**IEEE P802.15**  
**Wireless Personal Area Networks**

Project	IEEE P802.15 Working Group for Wireless Personal Area Networks (WPANs)	
Title	<b>TG3 D10 running comment resolutions</b>	
Date Submitted	[8 July, 2002]	
Source	[James P. K. Gilb] [Apparent Technologies] [9921 Carmel Mountain Rd. #247, San Diego, CA 92129]	Voice: [858-538-3903] Fax: [858-538-3903] E-mail: [gilb@ieee.org]
Re:	[]	
Abstract	[This document is a record of comment resolutions for LB17.]	
Purpose	[To provide a record of the comment resolution for LB17.]	
Notice	This document has been prepared to assist the IEEE P802.15. It is offered as a basis for discussion and is not binding on the contributing individual(s) or organization(s). The material in this document is subject to change in form and content after further study. The contributor(s) reserve(s) the right to add, amend or withdraw material contained herein.	
Release	The contributor acknowledges and accepts that this contribution becomes the property of IEEE and may be made publicly available by P802.15.

# 1. Comment resolution, Vancouver to Schaumburg

**Figure 2—MSC for the initiating of a neighbor piconet.**

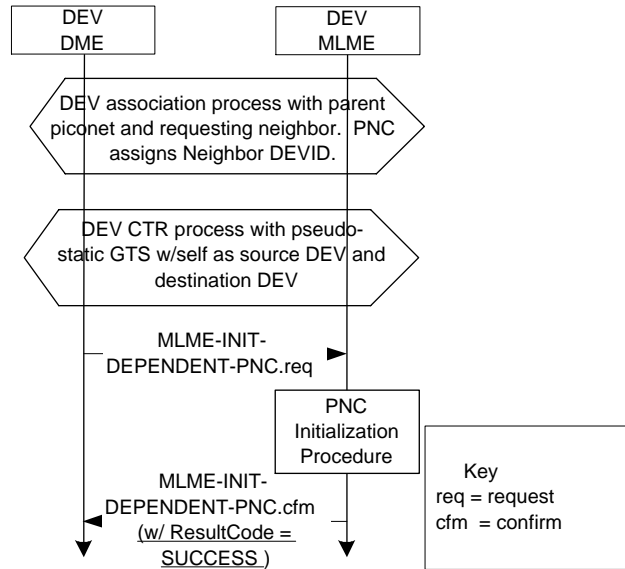
179 (Heberling, TR) - Figure 98 should be replaced with a proper MSC of the required protocol needed to establish a neighbor piconet. Replace figure 98 with a proper MSC. **Suggest accept** - An MSC for neighbor piconet initialization is included below. It needs twiddling to get the vertical lines to not show in the hex process blocks. Also, although consistent with other similar diagrams, this MSC seems to need the first beacon of the neighbor PNC shown.

The MSC for the initiation of the neighbor piconet is illustrated in Figure 4.

Accept in principle, “Accept suggested resolution but add a line at the bottom that shows the first beacon being sent. Also add after the sentence that says ‘The MSC for the initiation a neighbor piconet is illustrated in Figure 4.’ the following sentence, ‘The association and channel time request processes are defined in xref and xref, respectively.’”

**Figure 3—MSC for the creating a child piconet.**

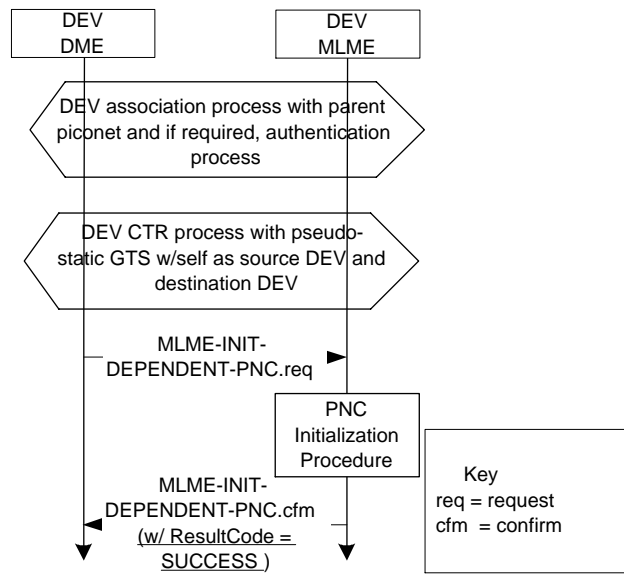
177 (Heberling, TR) - Figure 96 should be replaced with a proper MSC of the required protocol needed to establish a child piconet. Replace figure 96 with a proper MSC. **Suggest accept** ‘An MSC for child piconet initialization is included below. It needs twiddling to get the vertical lines to not show in the hex process blocks. Also, although consistent with other similar diagrams, this MSC seems to need the first beacon of the child PNC shown.

The MSC for creating a child piconet is illustrated in Figure 2.

Accept suggested resolution but add a line at the bottom that shows the first beacon being sent. Also add after the sentence that says ‘The MSC for creating a child piconet is illustrated in Figure 2.’ the following sentence, ‘The association and channel time request processes are defined in xref and xref, respectively.’

Figure 4—MSC for a approved asynchronous channel time request

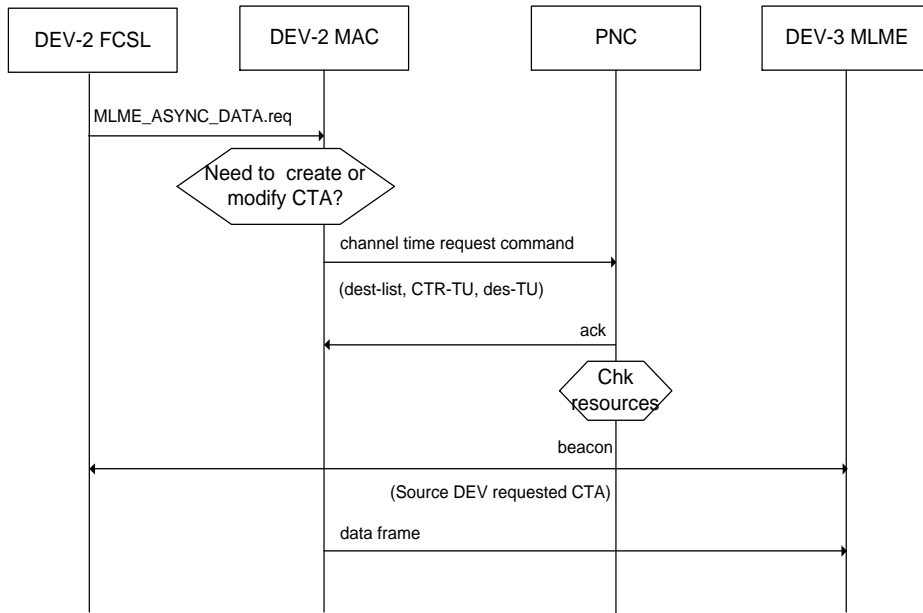
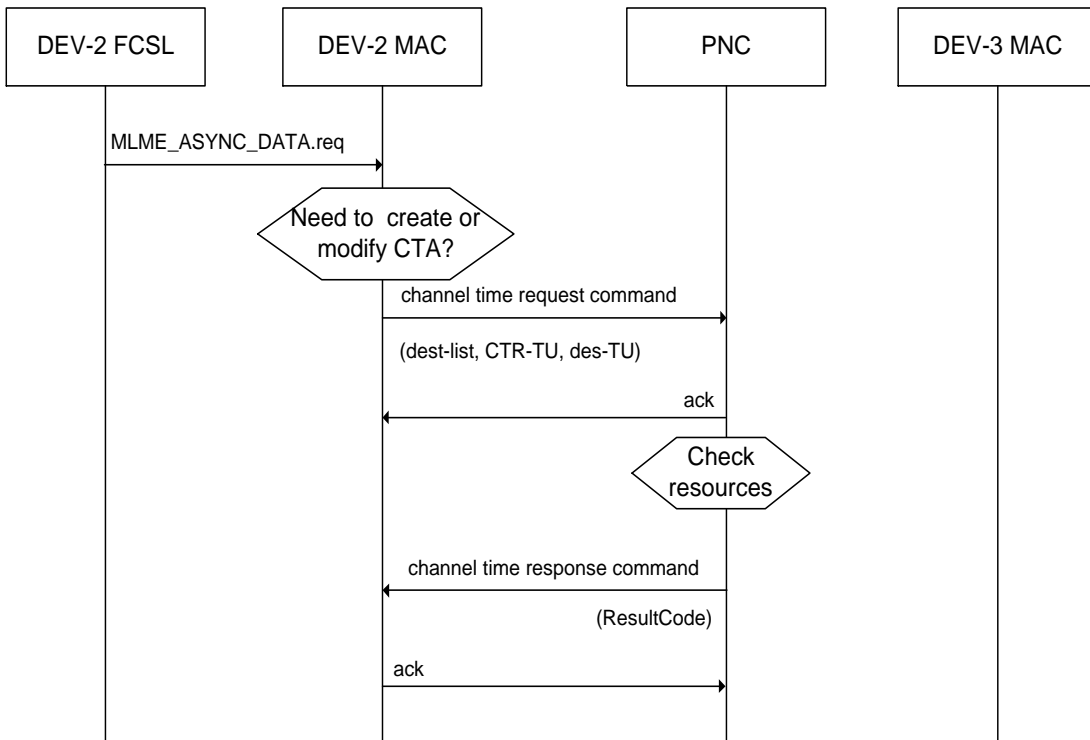
327 (Heberling, TR) Figure 119 is a flawed MSC of the Asynchronous channel time reservation process and data frame exchange. Consequently, delete the current MSC from this section of clause 8.5.2.1 and replace it with 02r0P802-15\_TG3-Asynch-channel-time-allocation.eps. **Suggest accept**.

Figure 119 – MSC for reserving asynchronous data channel time. Discussed earlier, new MSC is below:
